ALDI #13

CONGRESS BUSINESS PARK P.U.D.

REVISIONS:			
REV.	DATE	COMMENT	BY
1	05/07/14	REVISED PER TOWN COMMENTS	AAM

COMMENTS FROM TOWN OF LAKE PARK REVIEW FROM JULY 7TH, 2014 SUBMITTAL

1 SOUTH ELEVATION
SCALE: 1/8" = 1'-0"

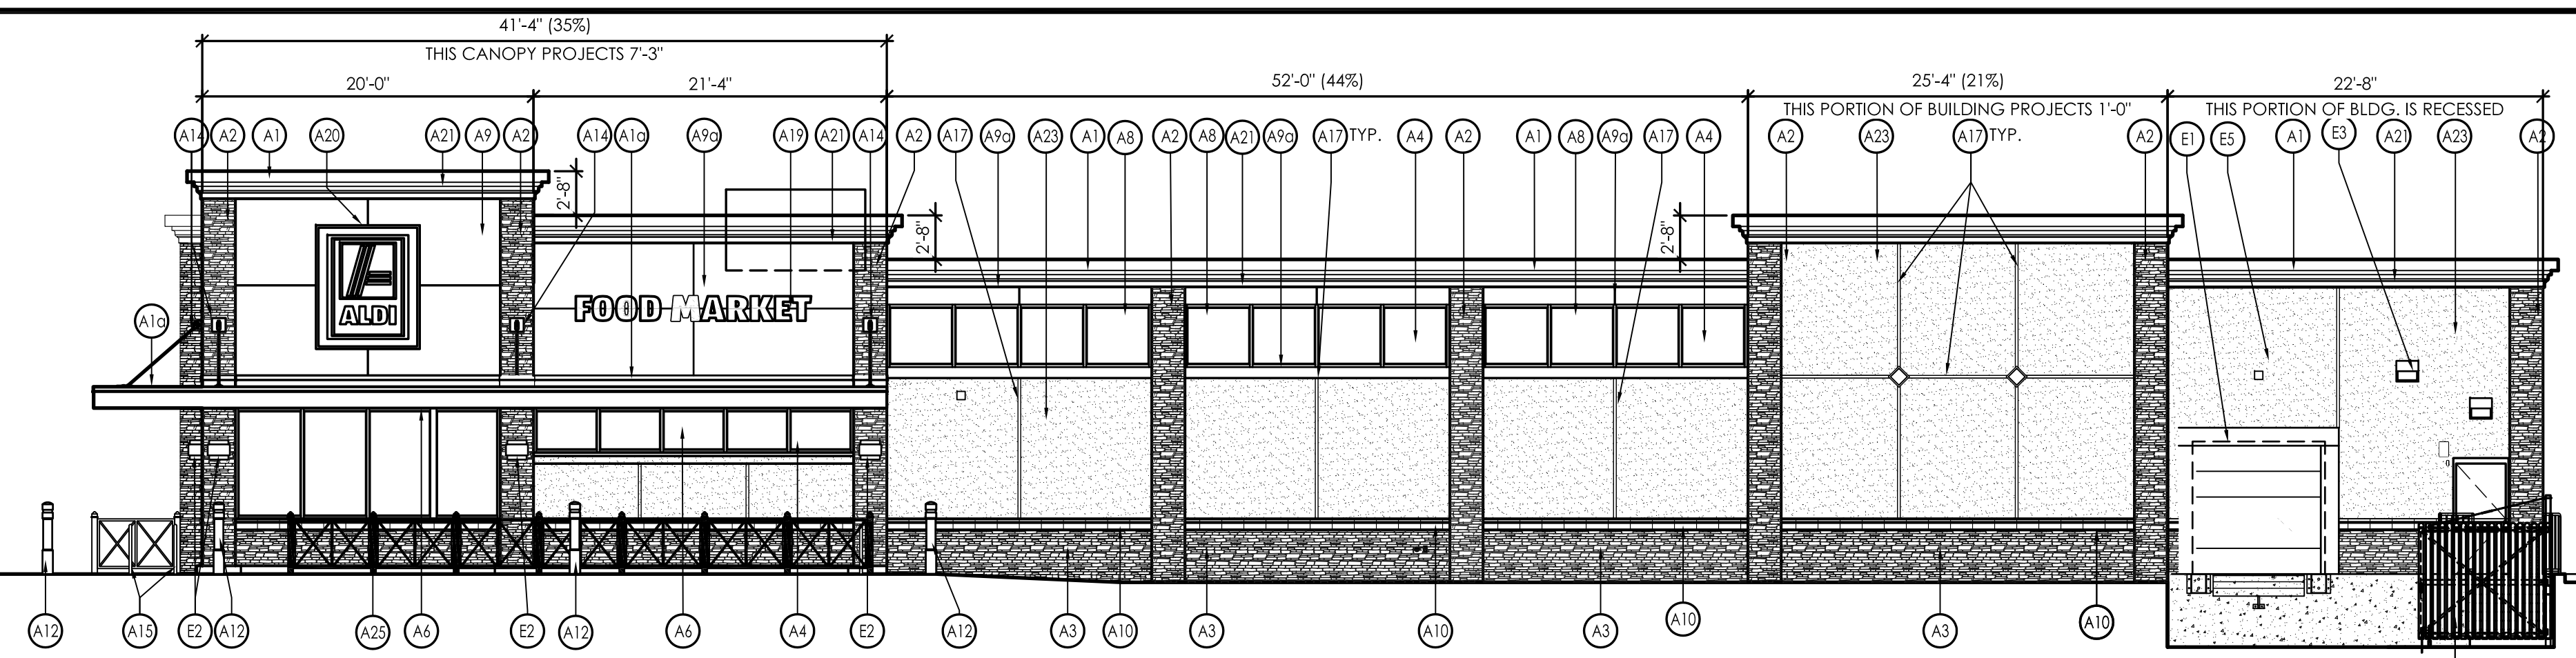
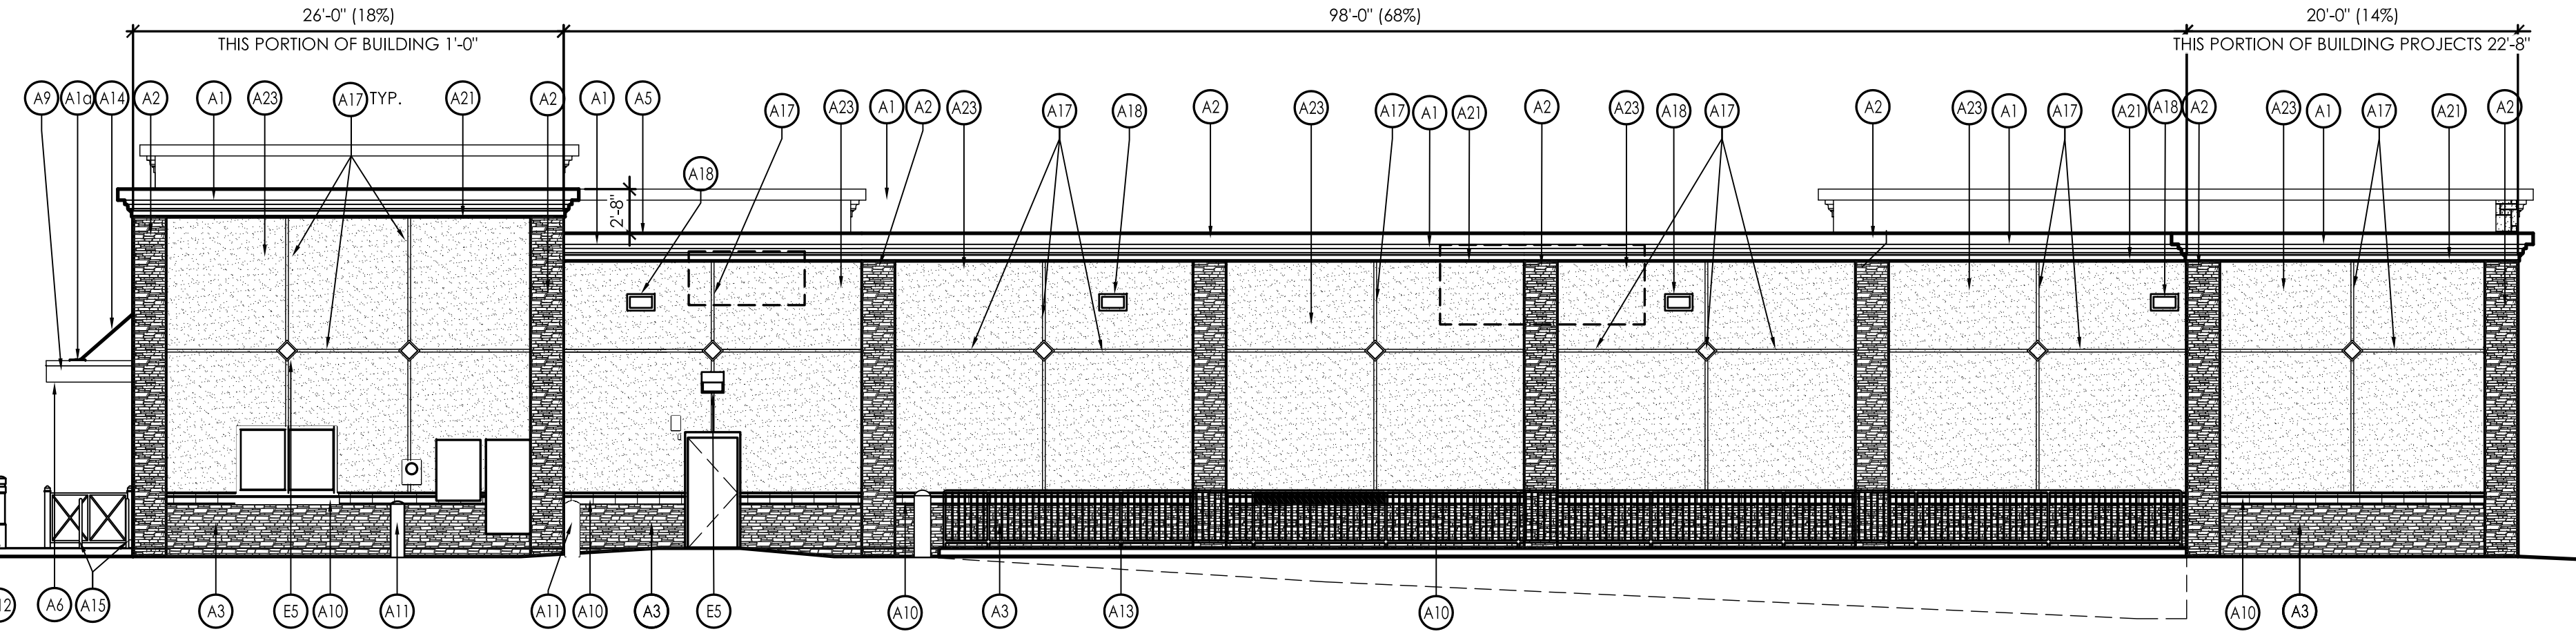
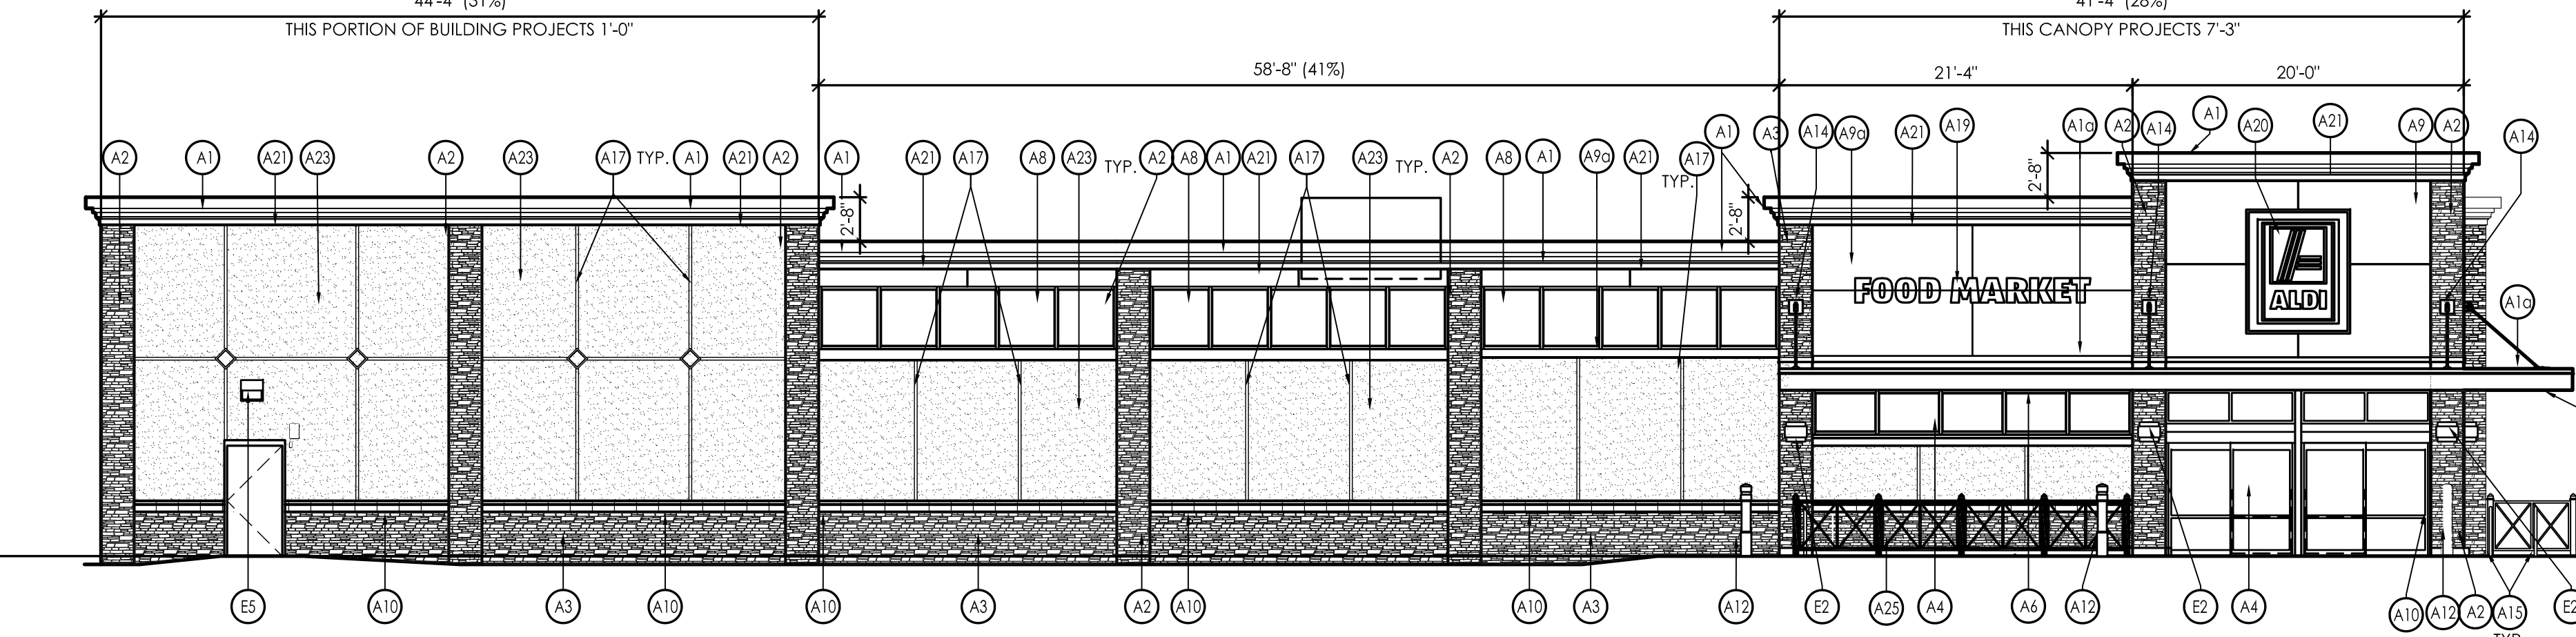
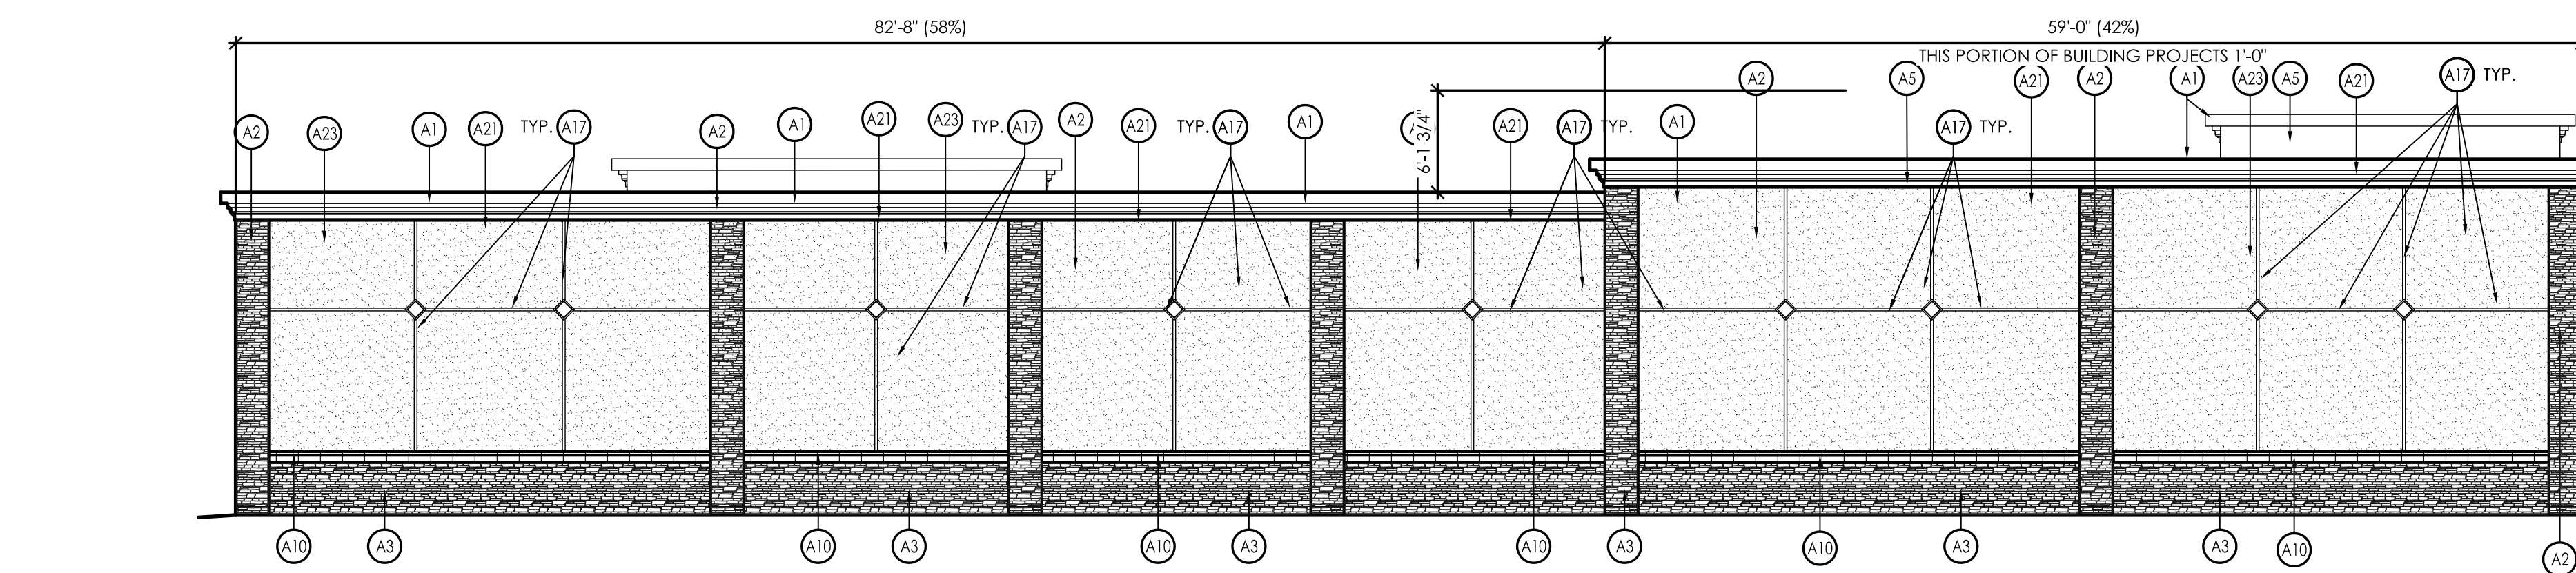
ITEM #11 DUMPSTER IS IN THE LOADING DOCK AREA PLEASE SEE FLOOR AND SITE PLAN.

ITEM #12 THE FLOOR PLAN AND ELEVATION INCLUDES THE FOLLOWING ITEMS FROM 78-332. FROM 1. CANOPY WRAPPING FRONT ENTRANCE 39'-0" ALONG THE SOUTH AND WEST ELEVATIONS FROM 2. BENCH IS PROVIDED ON CIVIL DRAWINGS FROM 4. ORNAMENTATION, FAUX WINDOWSHAVE BEEN ADDED ON THE SOUTH AND WEST ELEVATIONS, 2" REVEALS HAVE BEEN ADDED IN THE STUCCO THE FORM A DECORATIVE PATTERN WITH DECORATIVE DIAMONDS FORMED IN THE STUCCO.

ITEM #13 ORNAMENTATION, FAUX WINDOWSHAVE BEEN ADDED ON THE SOUTH AND WEST ELEVATIONS, 2" REVEALS HAVE BEEN ADDED IN THE STUCCO THE FORM A DECORATIVE PATTERN WITH DECORATIVE DIAMONDS FORMED IN THE STUCCO.

ITEM #14 PLASTERS PROJECT FROM ALL WALL SURFACES AND SEE FLOOR PLAN ON WHERE PORTIONS OF WALL PROJECT (SEE BELOW)

ITEM #17 ALL WINDOWS (FAUX AND STOREFRONT) BREAK THE EXTERIOR SHELL OF THE BUILDING TO APPEAR AS REAL WINDOWS. ONLY THE LOW WINDOWS ARE REAL WINDOWS WERE THE FRAME CAN BE SEEN FROM THE INSIDE.

ITEMS #29 CARDINAL NOTATIONS HAVE BEEN ADDED TO THE DRAWINGS

ITEM #7 GATE HAS BEEN ADDED TO SCREEN DUMPSTER PLEASE SEE FLOOR PLAN AND ELEVATIONS

WE HAVE ALSO ADDED RAILING AROUND OUR CART CORRALS TO BE OF SIMILAR RAILING DESIGN AT THE PROPOSED RACE TRACK, AS WELL AS USED SIMILAR STONE PATTERN

BUILDING ELEVATIONS	
Drawing Name:	
Date: 08-22-14	Project No. 2130757
Type: RHFD-V5	
Drawn By: RJB	A-201
Scale: 1/8" = 1'-0"	Drawing No.

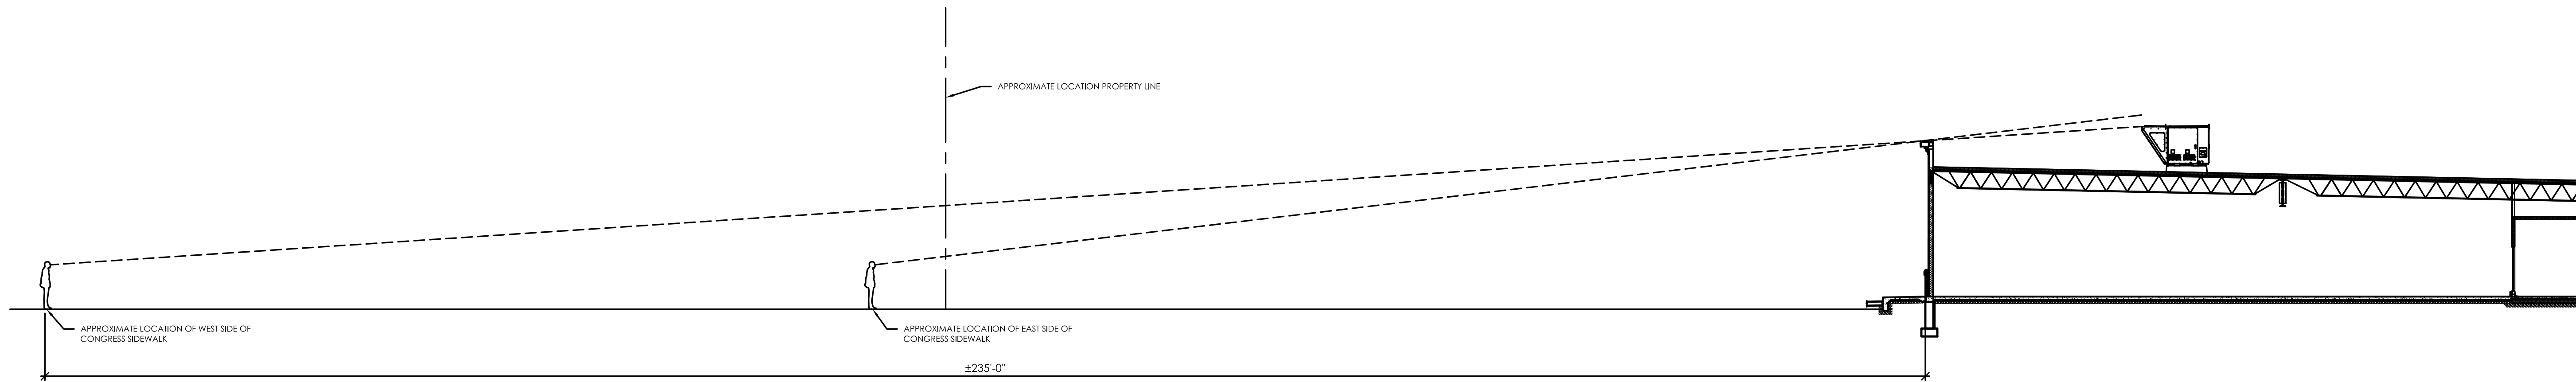
UNABLE TO SEE UNIT BECAUSE, THE HEIGHT OF THE PARAPET AND THE ANGLE IN WHICH YOU CAN VIEW THE MECHANICAL UNIT MAKES VIEWING THE HVAC UNIT VERY UNLIKELY FROM THE SIDEWALK
